Access Compliance Report

Public Rights-of-Way

Intersection ID: 23151	Main Street: LAUREL_POINTE_WY	Cross Street: MOSS_RD	Location: NW
ADA ID: 80257871F1C9	Ramp Type: Perp	Initial Pass/Fail: Fail	Overall Compliance: No Severity Score: 13.75

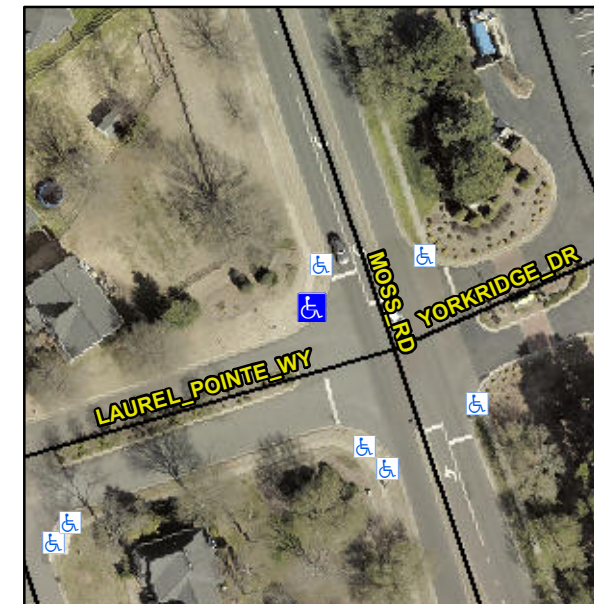
Not Found, R304.2.2, R304.5.3

Compliance	Description	Data	Compliance	Description	Data
N/A	Ramp Length (in)	123.0	No	Ramp Slope (%)	9.4
Yes	Ramp Width (in)	48.0	No	Ramp XSlope (%)	4.8
N/A	Flare Type LT	N/A	N/A	Flare Type RT	N/A
N/A	Flare Slope LT (%)	N/A	N/A	Flare Slope RT (%)	N/A
N/A	Flare Traversable LT?	N/A	N/A	Flare Traversable RT?	N/A
N/A	Landing Length (in)	N/A	N/A	DWS Provided?	N/A
N/A	Landing Width (in)	N/A	N/A	DWS Contrast?	N/A
N/A	Landing Slope (%)	N/A	N/A	DWS Length (in)	N/A
N/A	Landing X Slope (%)	N/A	N/A	DWS Full Width?	N/A
N/A	Landing Curb? (Y/N)	N/A	N/A	DWS Offset (in)	N/A
N/A	Shared Landing?	N/A			
N/A	Gutter Ponding?	N/A	N/A	Gutter Slope (%)	N/A
N/A	Gutter Lip Ht (in)	N/A	N/A	Gutter X Slope (%)	N/A
N/A	Painted X Walk1?	No	N/A	Painted X Walk2?	N/A
	X Walk 1 Direction	To SE		X Walk 2 Direction	N/A
N/A	X Walk 1 Width (in)	N/A	N/A	X Walk 2 Width (in)	N/A
	X Walk 1 Slope (%)	3.7		X Walk 2 Slope (%)	N/A
	X Walk 1 X Slope (%)	5.8		X Walk 2 X Slope (%)	N/A

Remove & Replace Entire Ramp.
